City of Westlake

Planning and Zoning Department – Staff Report

PETITION NUMBER: SPM-2021-08 *Grove Market at Westlake Site Plan Modification*
APPLICANT: Gentile Holloway O’Mahoney & Associates, Inc.
OWNER: 5060 Loxahatchee Retail LLC
LOCATION: 5060 Seminole Pratt Whitney Road
PCN: 77-40-43-01-01-001-0010
REQUEST: Application for a Site Plan Modification to upgrade the Grove Market at Westlake site plan in the Mixed- Use Zoning District. The application includes a landscaping plan; and, improvements to the parking area, the dumpster enclosures and the covered walking area.

DATE: 9/24/2021
APPLICATION NUMBER: SPR-2021-08
DESCRIPTION: Grove Market Site Plan Review
APPLICANT: 2GHO, Inc.
OWNER: 5060 Loxahatchee Retail, LLC
REQUEST: Site Plan Modification Review
LOCATION: 5060 Seminole Pratt Whitney Road, Westlake, FL 33470
STAFF REVIEW: **APPROVAL LETTER**

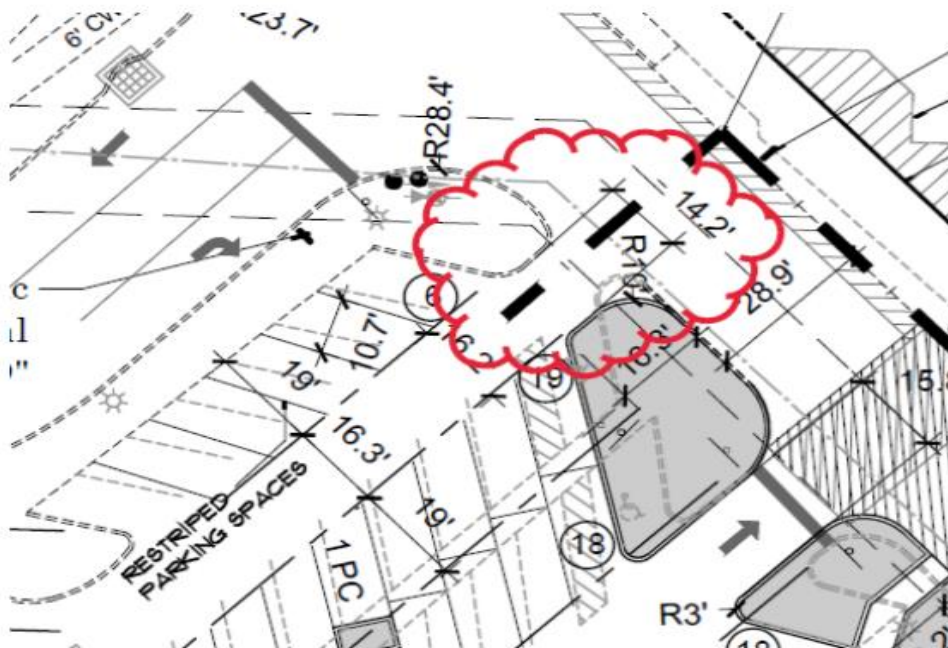
1. The abandoned left turn lane onto Seminole Pratt Whitney Rd. should be either striped or curbed and absorbed into the adjacent landscape island by expanding the landscape island and effective funneling traffic into one lane, right turn only. See sketch below for a visual example of how this could be achieved. Exact configuration may differ.

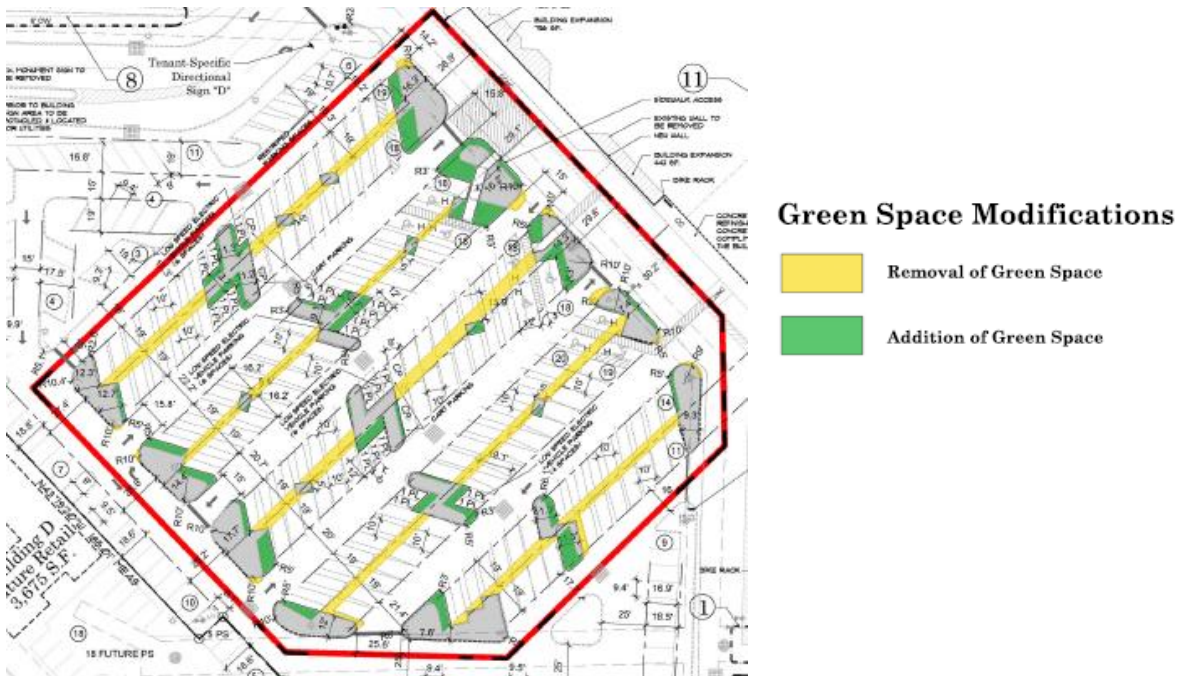
The existing landscape that was not in conformance with Code has been supplemented to conform. There are trees within the affected area of the parking lot that have been proposed for removal. As the parking lot exists currently, there are several trees that are in poor condition and also buckling the adjacent pavement. The parking lot redesign successfully preserves the healthy and viable canopy trees while selectively removing the trees that are in poor condition. The redesigned landscape within the affected area of the parking lot has been reviewed and is in compliance with City Code.

The image below highlights the locations of the proposed landscape:

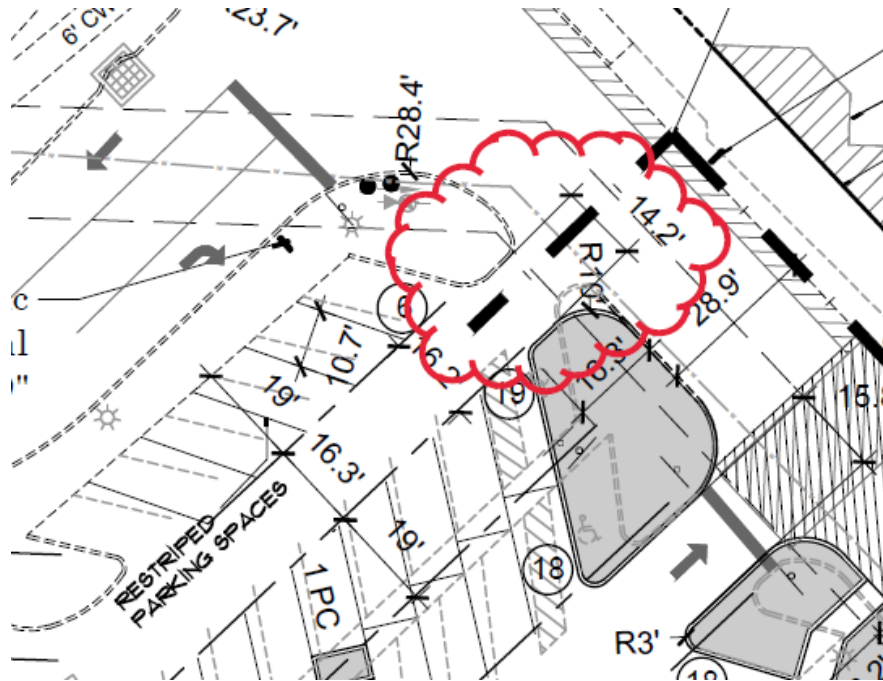
1. The abandoned left turn lane onto Seminole Pratt Whitney Rd. should be either striped or curbed and absorbed into the adjacent landscape island by expanding the landscape island and effective funneling traffic into one lane, right turn only. See sketch below for a visual example of how this could be achieved. Exact configuration may differ.
